Form 3160 -3 (March 2012)

## PECOS DISTRICT DRILLING OPERATIONS CONDITIONS OF APPROVAL

WELL NAME & NO.: 111H-Pennzoil 32 Fed SURFACE HOLE FOOTAGE: 330'/N & 220'/W BOTTOM HOLE FOOTAGE 330'/N & 240'/W, 32

OPERATOR'S NAME:
LEASE NO.:
WELL NAME & NO.:
SURFACE HOLE FOOTAGE:
BOTTOM HOLE FOOTAGE
LOCATION:
COUNTY:
Matador Production Company
NMNM04825
111H-Pennzoil 32 Fed
330'/N & 220'/W
330'/N & 240'/W, 32
Section 33, T.20 S., R.29 E., NMPM
Eddy County, New Mexico

Figure 1. Cross-sections and plans for typical road sections representative of BLM resource or FS local and higher-class roads.

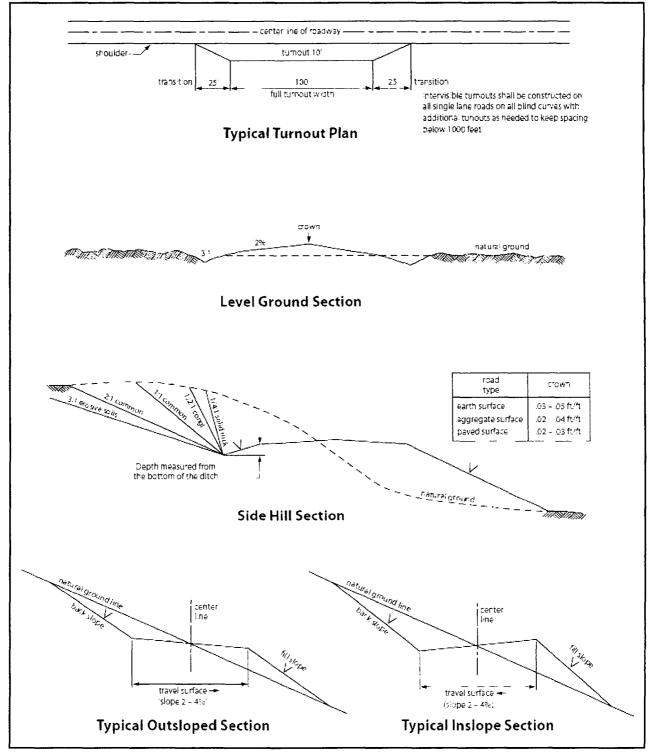
Crowning shall be done on the access road driving surface. The road crown shall have a grade of approximately 2% (i.e., a 1" crown on a 14' wide road). The road shall conform to Figure 1; cross section and plans for typical road construction.

Vehicle turnouts shall be constructed on the road. Turnouts shall be intervisible with interval spacing distance less than 1000 feet. Turnouts shall conform to Figure 1; cross section and plans for typical road construction.
